Addendum #3

Bid Opportunity: 25-7693-RFT - Elmira District Secondary School Weight Room Renovation Closing Date: Thursday, March 20, 2025 2:00 PM

WRDSB-Elmira District Secondary School Weight Room Renovation
WRDSB Project No.: 25-7693-RFT
WF Project No.:2022-0277-15

March 13, 2025
ADDENDUM #3
Page 1 of 2

1.0 Reference Attached Reissued Drawing E2.1

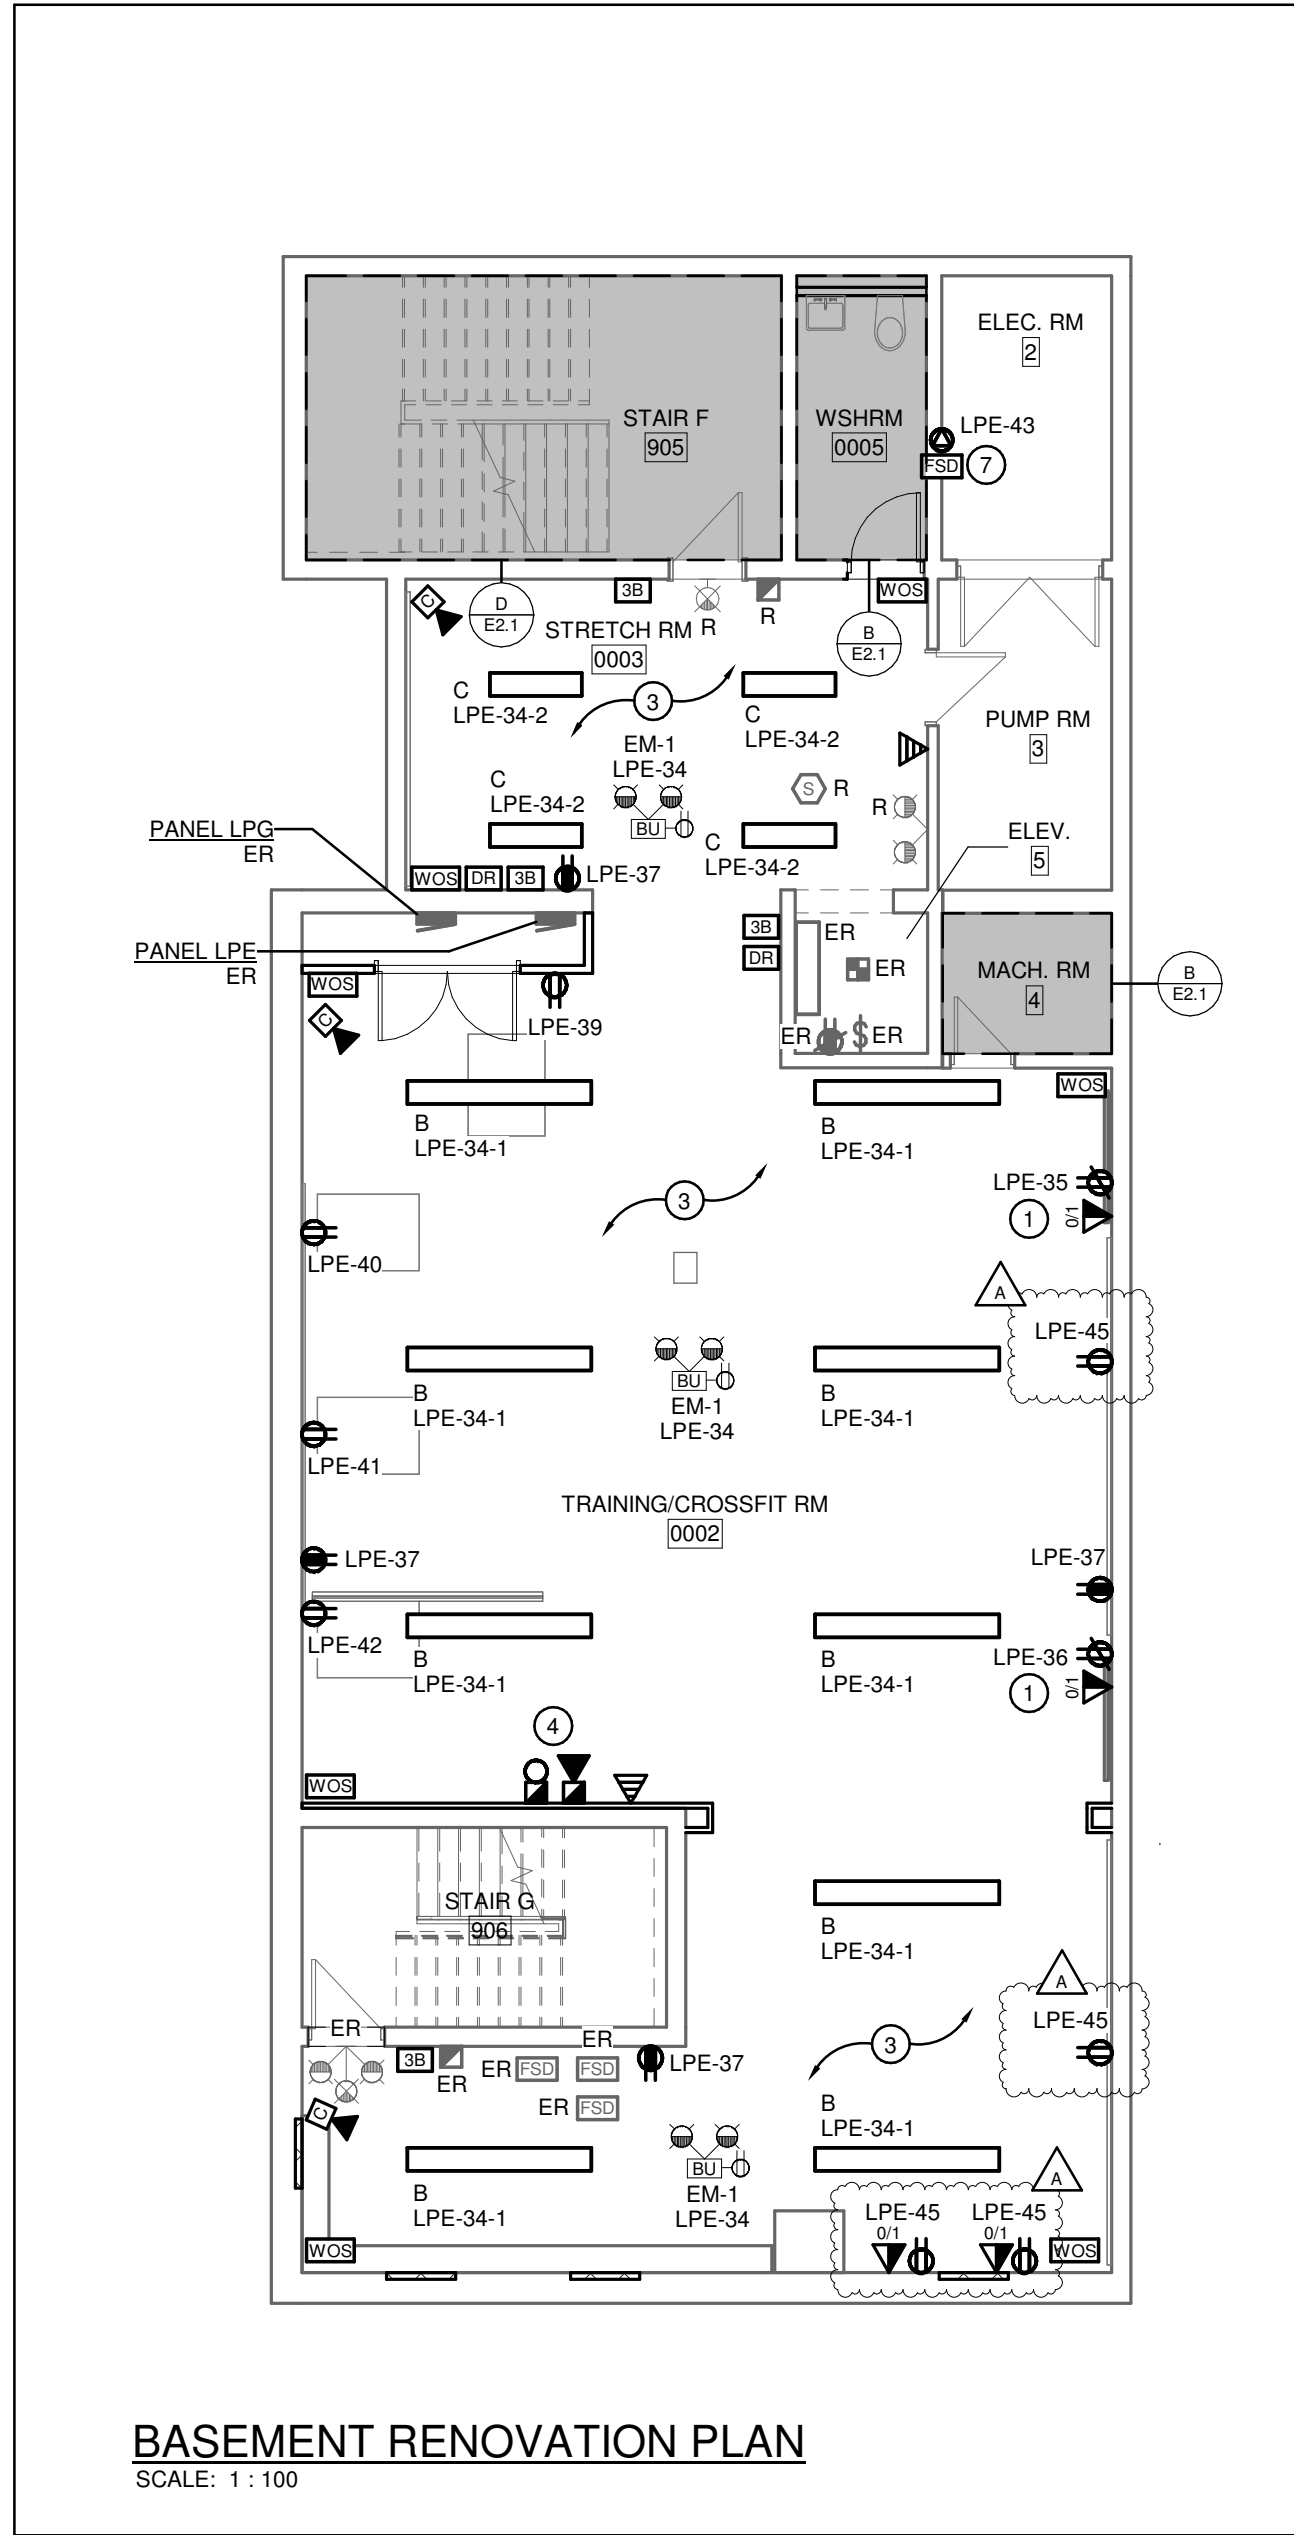
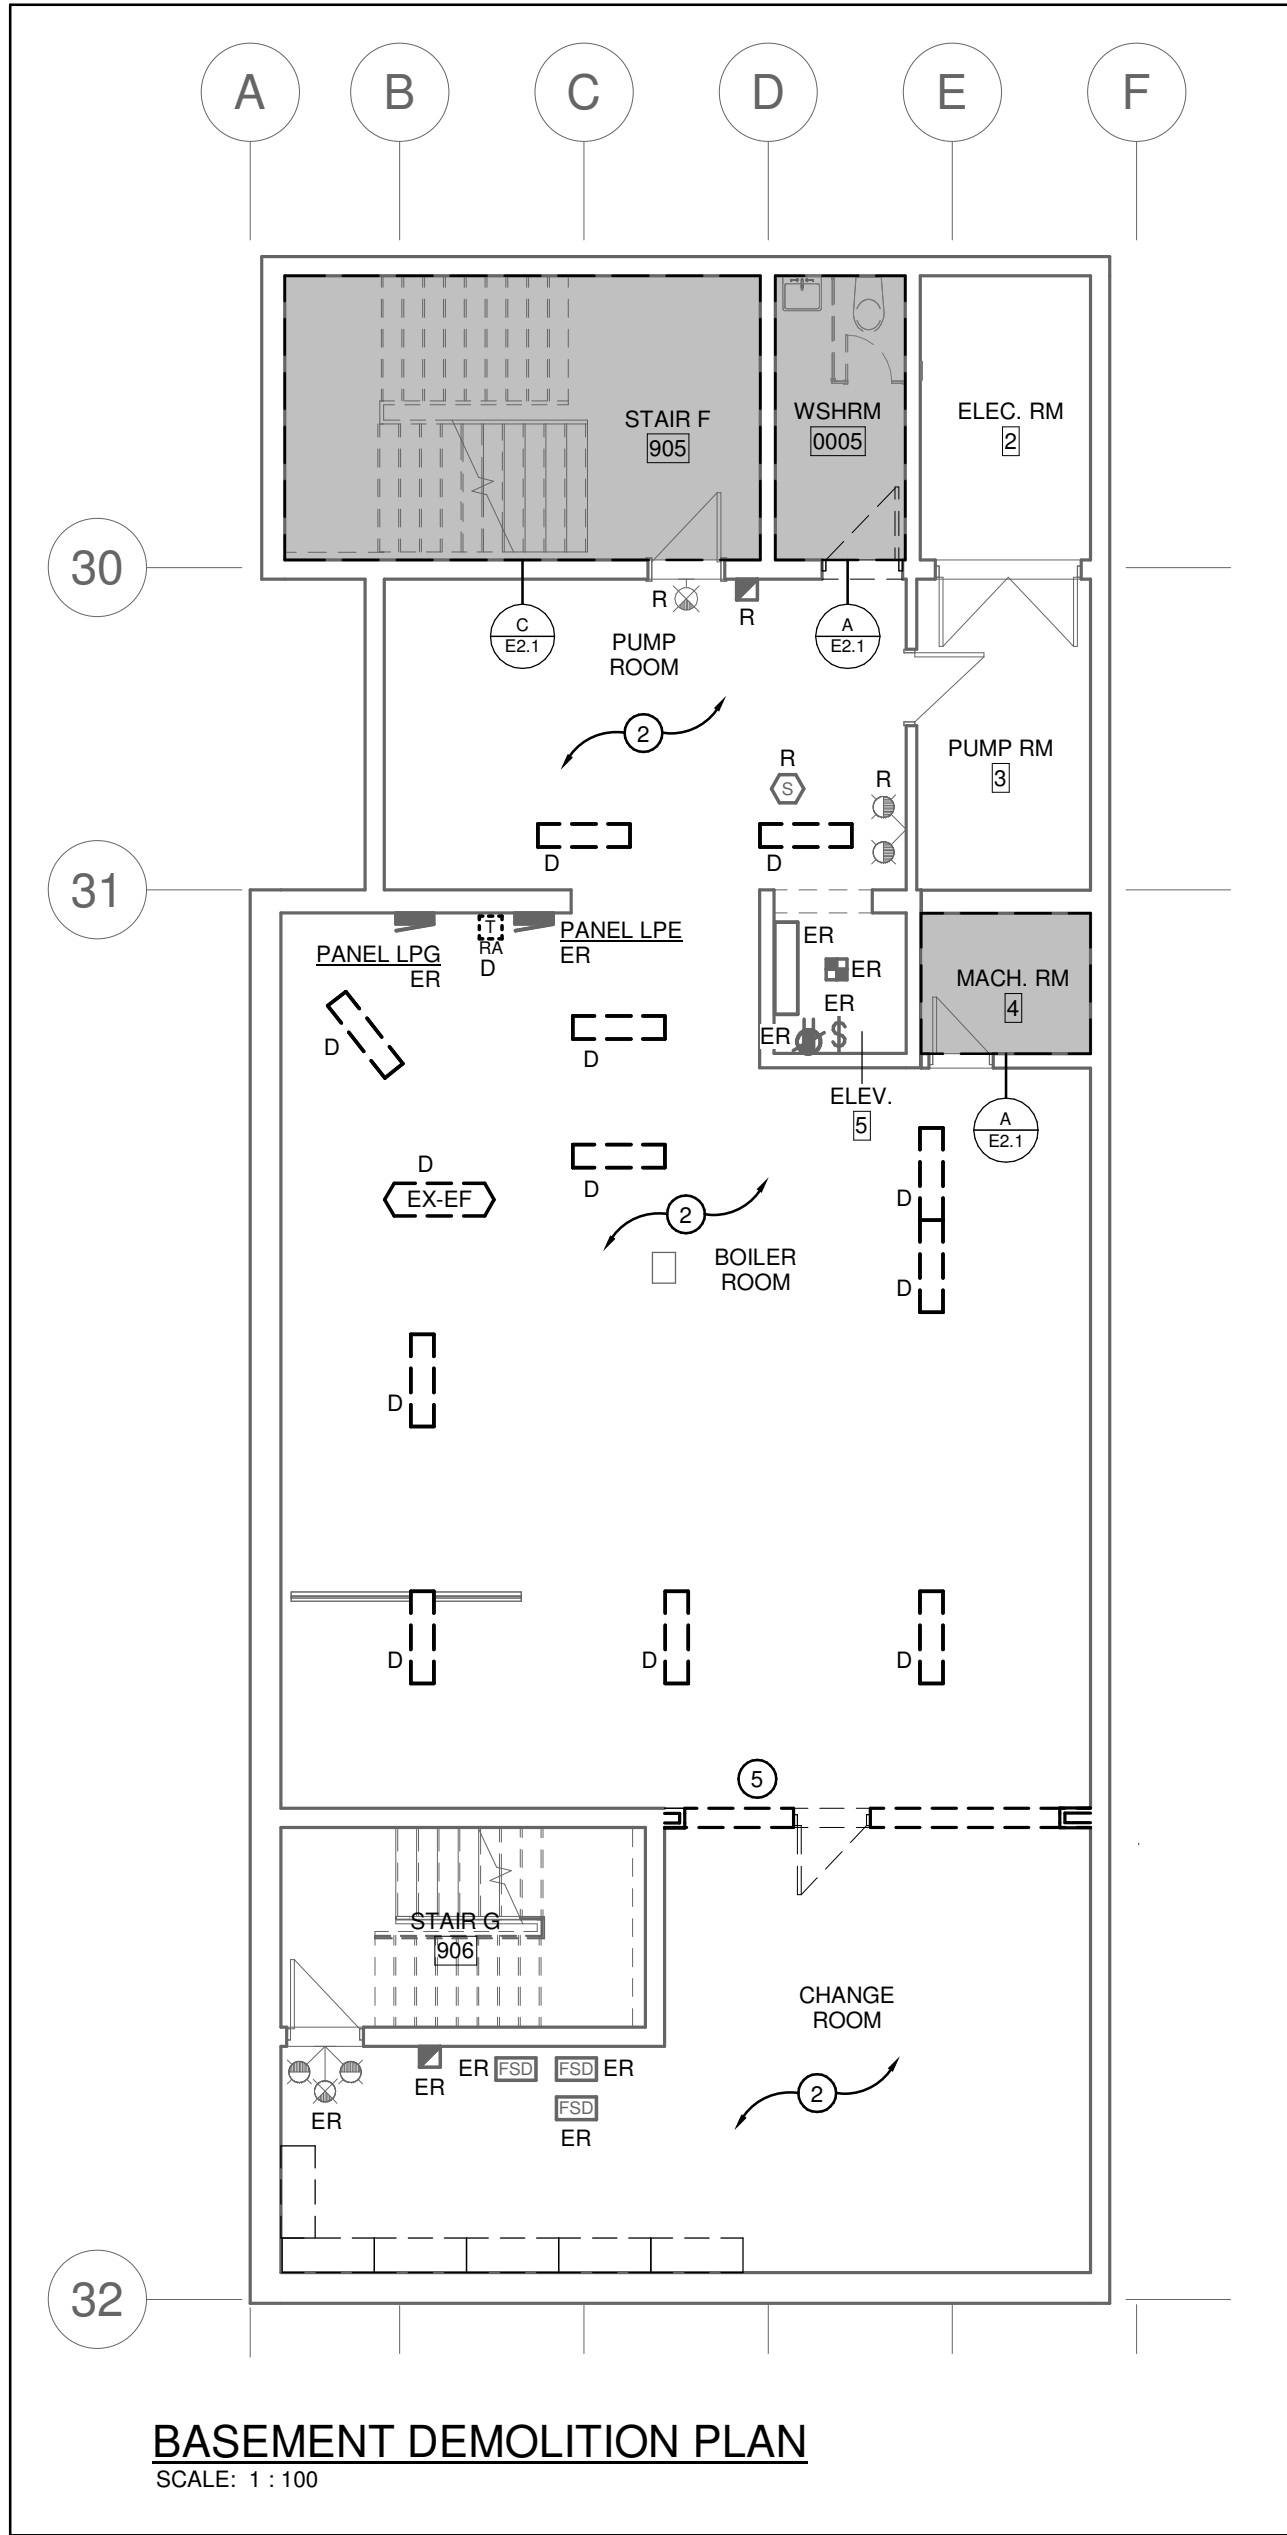
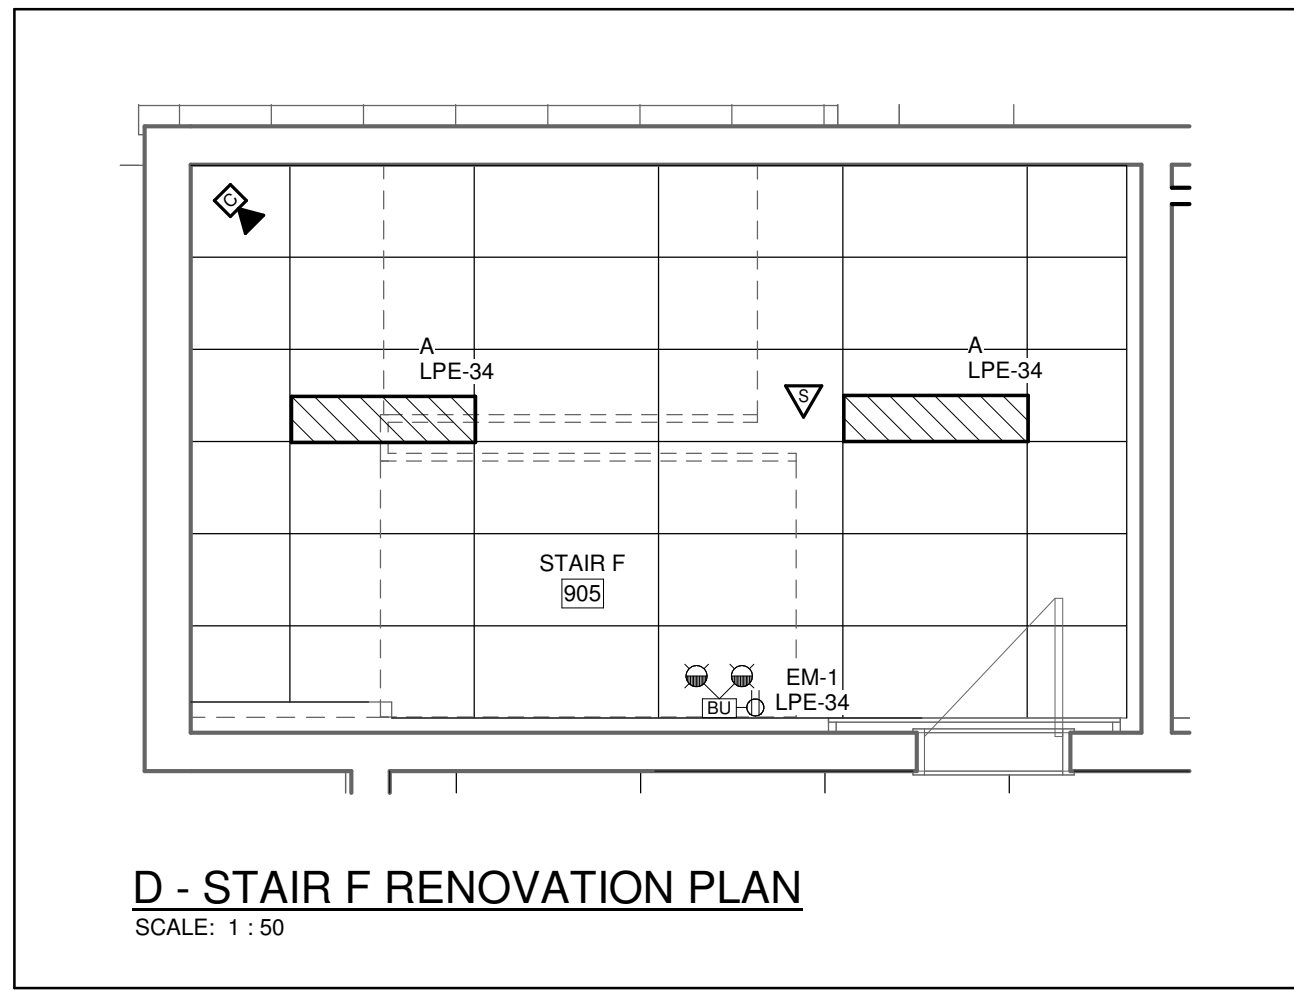
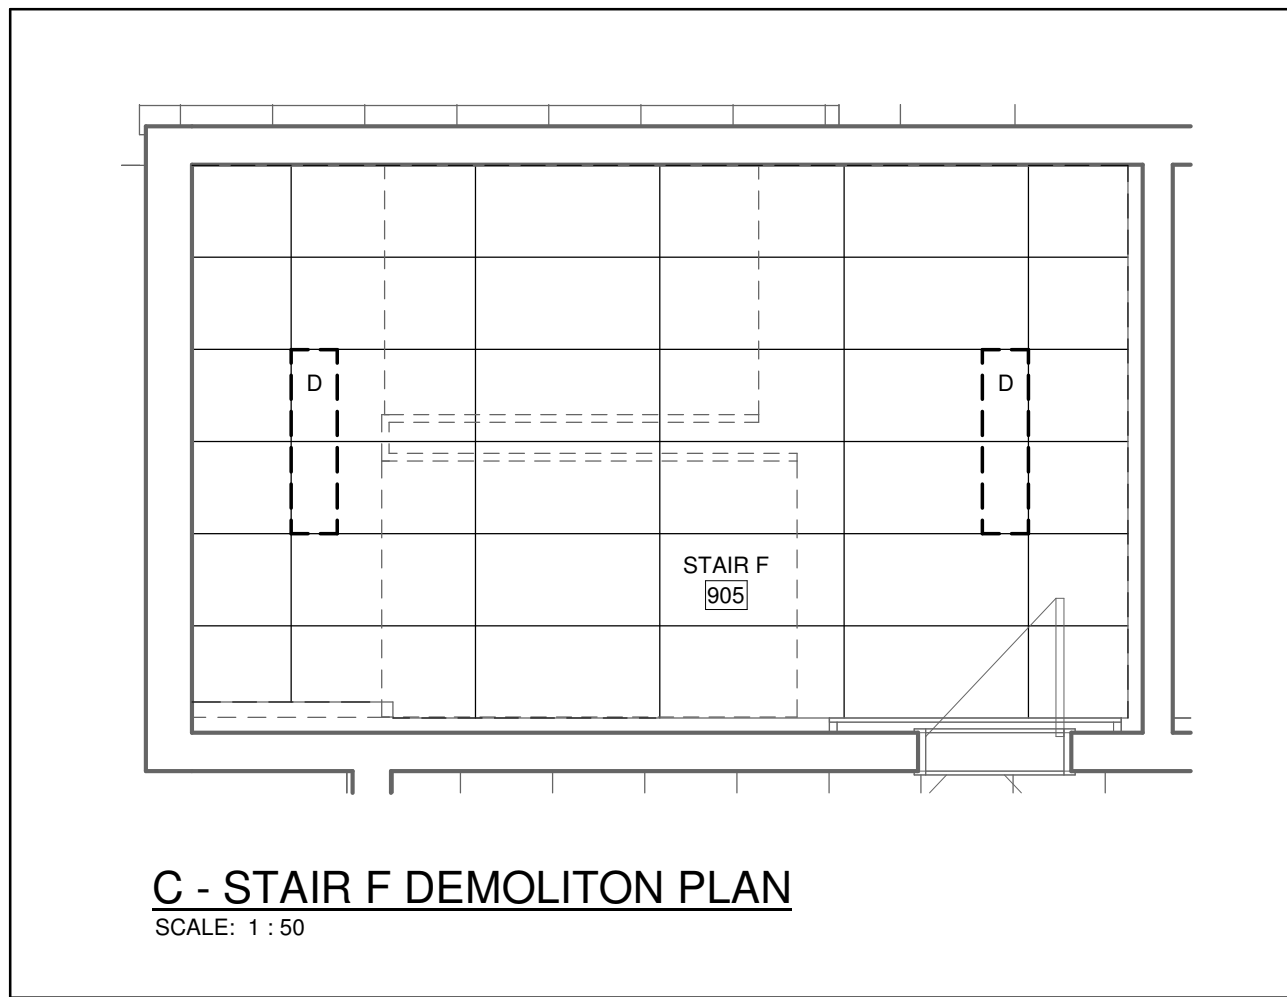
- .1 Supply and install four (4) receptacles and two (2) data outlet rough-ins as shown on attached reissued drawing E2.1. Wall is to be fished in location block work is happening, provide wiremold as required for other outlets. Coordinate mounting heights with architectural elevations.
